SERVICE BULLETIN

SB-092718 REV A

DATE ISSUED: 10/16/2018
DATE EFFECTIVE: 10/16/2018
SUPERSEDES NOTICE: N/A
SUBJECT: Fuel level sensor gasket

REQUIRED ACTION: Inspect fuel level sensor for non-conformance. Replace non-conforming units.

Figure 1 – Washer shown under jam nut.

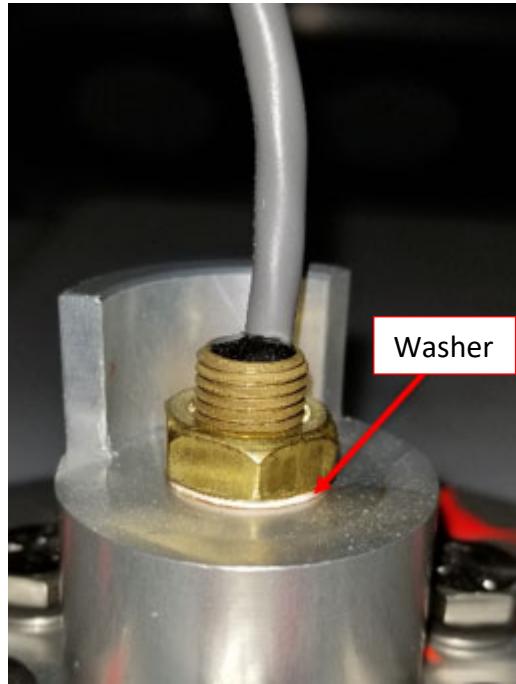
1. It is permissible to disassemble the aircraft as required to permit accessibility, inspection, adjustment, maintenance, and repair in accordance with the latest release of the Aircraft Maintenance Manual, ICA000833.
 - a. Remove baggage floor.
 - b. Remove seat backs as needed.
2. Visually inspect the top of the PROBE, FUEL LEVEL SENSOR for a washer underneath the jam nut, Figure 1:
 - a. If there is no washer underneath the jam nut, no further action is required. Re-install the interior panels.
 - b. If there is a washer underneath the jam nut, this is a non-conforming fuel level sensor. Proceed to preparation and installation instructions.

Figure 4 – Fuel level sensor being removed from bladder fuel tank.

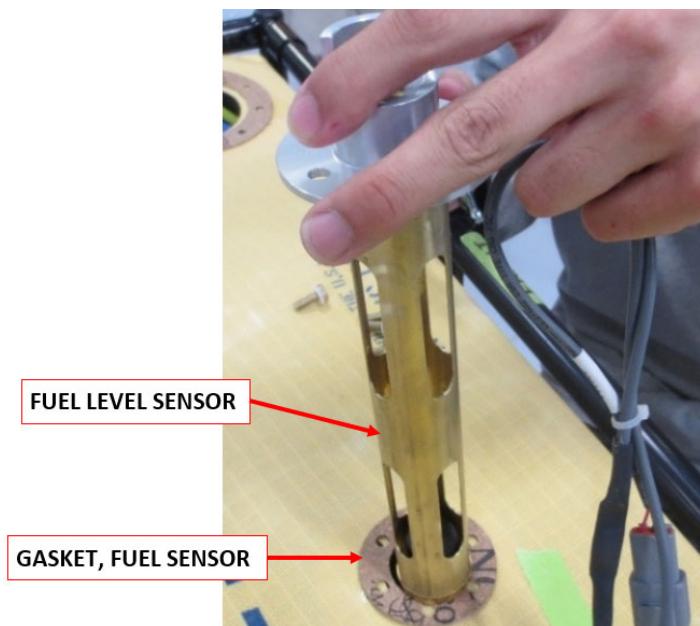
- a. Disconnect the fuel level sensor connector from D9039P on the fuselage wire harness.
 - b. Remove three cable ties securing the fuel level sensor harness.
 - c. Remove two bolts, two washers, and ring terminals T9028 and T1979 from the fuel level sensor.
3. Remove fuel level sensor, Figure 4:
- a. Remove the four remaining bolts and washers on the fuel level sensor.
 - b. Remove the fuel level sensor and gasket.

NOTE: If when removed the brass housing on the fuel level sender has 8 x 0.25 in circular holes (16 total) rather than long slots that are shown in figure 4 contact ICON Support for further instruction.

Figure 10 – Fuel level sensor orientation.

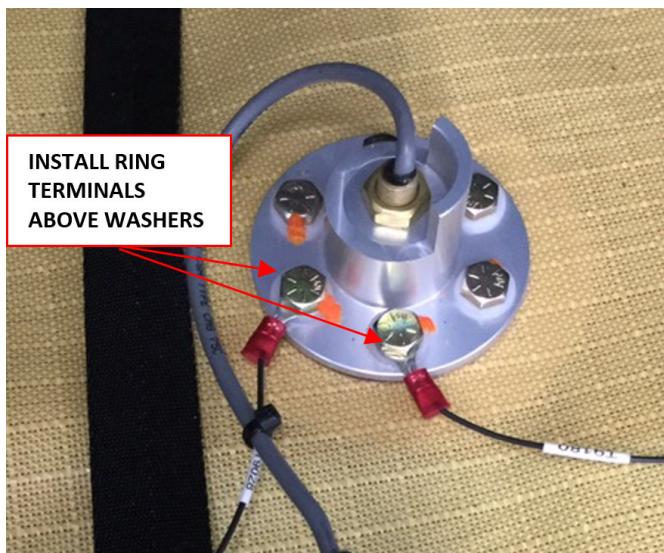
1. Install new PROBE, FUEL LEVEL SENSOR into bladder fuel tank, Figure 10:
 - a. Clean fuel level sensor plate with ISOPROPYL ALCOHOL.
 - b. Orient PROBE, FUEL LEVEL SENSOR as shown and install into bladder fuel tank using a new FUEL SENSOR GASKET, four bolts, and four washers previously removed.

- i. Two additional bolts and washers are installed in a later step.
2. Secure the electrical connections to the fuel level sensor, Figure 3, 7 & 10:
 - a. Install two remaining bolts, washers, and ring terminals T9028 and T9026 ring onto the fuel level sensor. Position the ring terminals as shown and above the nylon washers.

Figure 11 – Fuel level sensor installation.

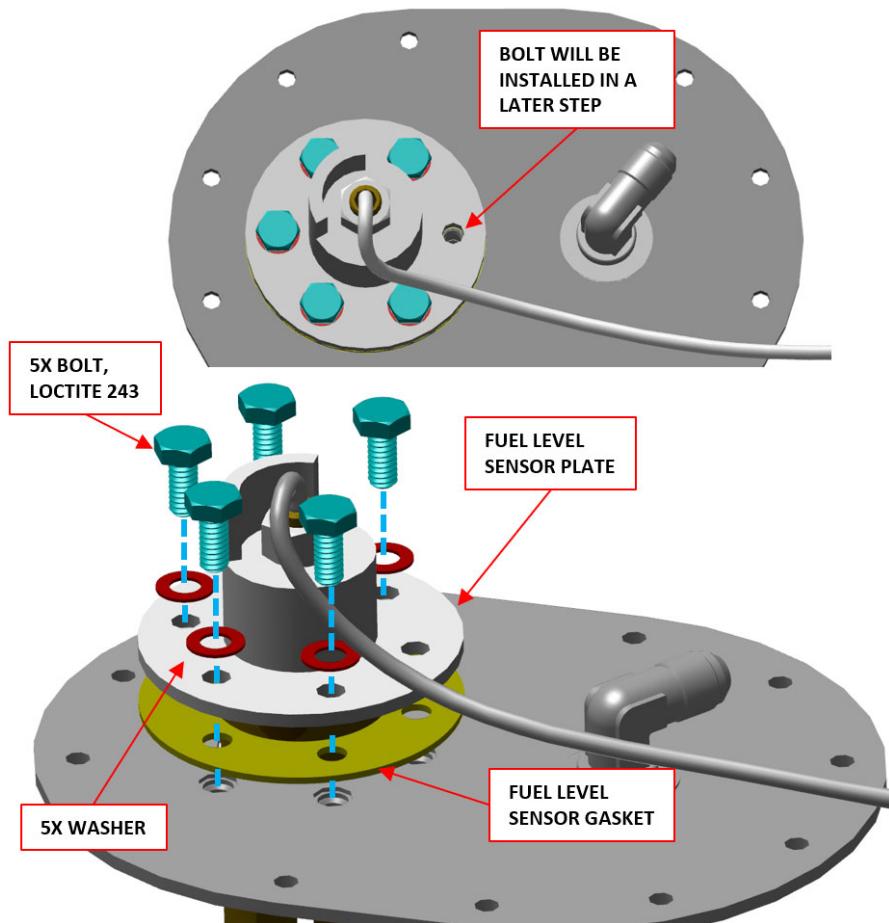
1. Install new PROBE, FUEL LEVEL SENSOR onto fuel tank access plate, Figure 11 & 12:
 - a. Clean fuel level sensor plate with ISOPROPYL ALCOHOL.
 - b. Orient PROBE, FUEL LEVEL SENSOR as shown and install into fuel access plate using a new FUEL SENSOR GASKET, THREADLOCKER, five bolts, and five washers previously removed. Torque bolts in a star shaped pattern to 40-45 in-lb.

Figure 12 – Clamp bracket position.

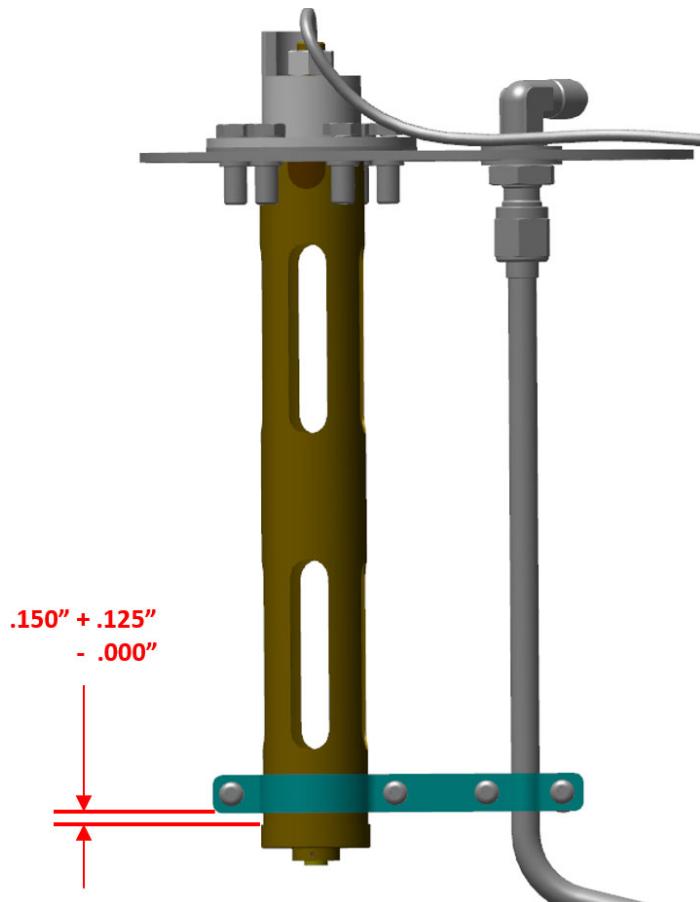
- c. Position clamp bracket on fuel level sensor as shown in Figure 12.
 - d. Install two washers, nut, and Torx screw on clamp bracket. While maintaining this position, torque Torx screws on clamp bracket to 7-10 in-lbs.

Figure 13 – Fuel Tank Access Plate Gasket & Torque Sequence

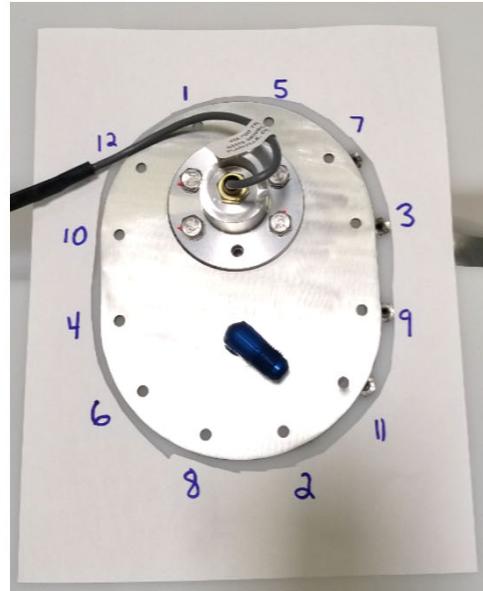
2. Install fuel level sensor assembly into fuel tank, Figure 8 & 13:
 - a. Clean fuel access plate with ISOPROPYL ALCOHOL.
 - b. Apply SEALANT as one continuous bead approximately .030" - .060" thick to *both* sides of the GASKET, ACCESS PLATE.

- i. SEALANT to be applied as straight lines between bolt holes and half crescents to the interior around the bolt holes.
 - ii. Allow SEALANT to sit for 5 minutes after being applied to GASKET, ACCESS PLATE

- e. Secure fuel tank access plate to fuel tank using THREADLOCKER, 12 nuts and washers previously removed.
 - i. Torque bolts 25-30 in-lb in a star shaped pattern as shown in Figure 13.

- ii. Repeat star shaped torque sequence 2-3 times to ensure that gasket is evenly compressed and that all bolts are torqued to specification.
3. Secure the electrical connections to the fuel level sensor plate, Figure 7:
